NOTICE OF DECISION TO CONSENT TO CHANGE TO PROPOSAL DURING ASSESSMENT

Shark Bay Resources Maintenance Dredging Assessment No. 2272

STATEMENT OF REASONS

Proposal: Shark Bay Resources Maintenance Dredging

Figure 1: Development envelope

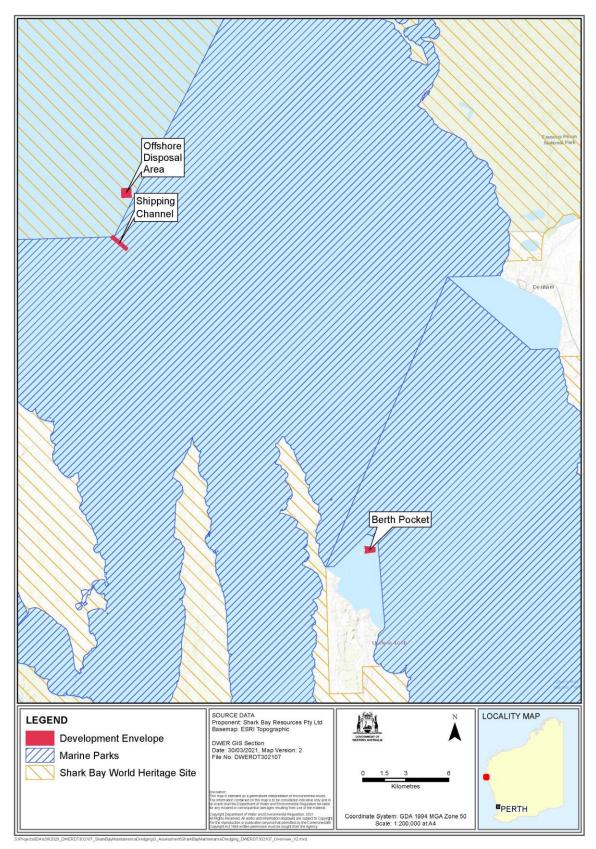
- 1) reduction in the extent of the dredge footprint from 63.4 hectares (ha) to 35.3 ha
- 2) reduction in the dredge material volume from up to 100,000 cubic metres (m³) to up to 80,000 m³ of sediment
- 3) reduction in the volume of dredge material to be disposed of at the offshore disposal area from up to 100,000 m³ to up to 80,000 m³ of sediment
- 4) addition of seabed levelling in the berth pocket of up to 10,000 m³ of sediment
- 5) updates to the key characteristics table to reflect the proposed changes.

The updated proposal summary (Table 1), key characteristics tables (Table 2) and figure depicting the development envelope (Figure 1) are attached to this Notice.

Element	Location	Proposed extent				
Physical elements						
Not applicable						
Operational elements						
Maintenance and capital dredging – entrance channel	Figure 1	Up to 80 000 m³ of material will be removed from the 35.3 ha channel entrance footprint to a maximum depth of -10.5 m lowest astronomical tide (LAT).				
Maintenance dredging – berth pocket	Figure 1	Up to 10 000 m ³ of material will be moved/levelled within the 28.1 ha berth pocket footprint to a maximum depth of -10 m LAT.				
Disposal area	Figure 1	Up to 80 000 m ³ of material disposed within the 43.2 ha offshore disposal area footprint.

Figure 1: Development envelope

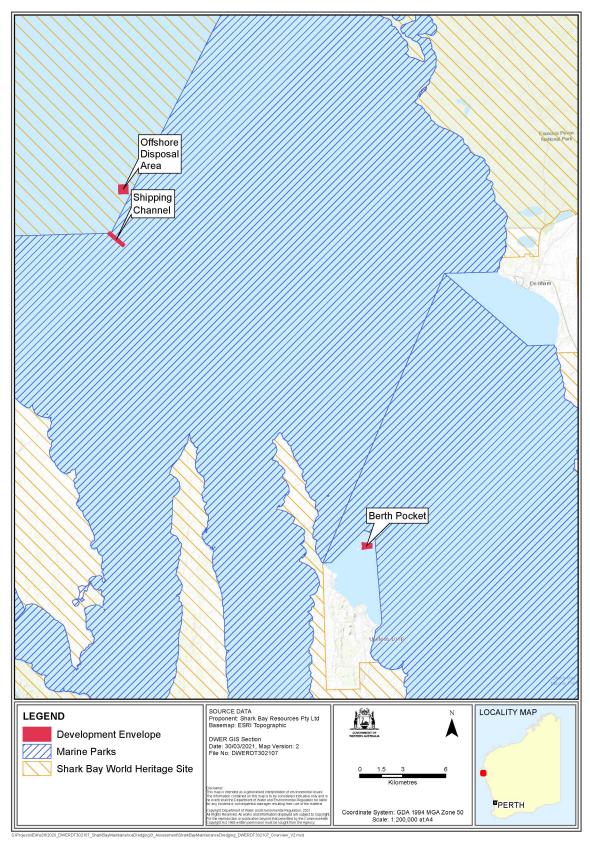
The removal of dredging from within the berth pocket results in a decrease in the total dredge volume of 20,000 m³ (from 100,000 m³ to 80,000 m³), with a subsequent reduction in the total volume of sediment to be disposed in the offshore disposal area. The dredge footprint decreases by 28.1 ha (from 71.3 ha to 43.2 ha). The dredge campaign duration decreases from up to four weeks to up to two weeks.

The updated key characteristics of the proposal are in the attached key characteristics table (Schedule 1) with the revised dredge footprint depicted in Figure 1.

Element	Location	Referred extent	Revised extent			
Physical elements						
Not applicable						
Operational elements						
Maintenance and capital dredging – entrance channel	Figure 1	Up to 80 000 m³ of material will be removed from the entrance channel to -10 m lowest astronomical tide (LAT), with sand trenches beyond the original design (-0.5 m) on both sides of the channel to limit slumping over time and reduce the requirement for maintenance into the future.	Up to 80 000 m³ of material will be removed from the 35.3 ha channel entrance footprint to a maximum depth of -10.5 m lowest astronomical tide (LAT).			
Maintenance dredging – berth pocket	Figure 1	Up to 20 000 m³ of material will be removed from the berth pocket to -10 m LAT. "No overflow" of the hopper proposed in selected areas where sampling indicated elevated TBT. Priority to dredge "contaminated" area first and cap with uncontaminated material.	Up to 10 000 m³ of material will be moved/levelled within the 28.1 ha berth pocket footprint to a maximum depth of -10 m LAT.

Disposal area	Figure 1	N/A	Up to 80 000 m ³ of material disposed within the 43.2 ha offshore disposal area.
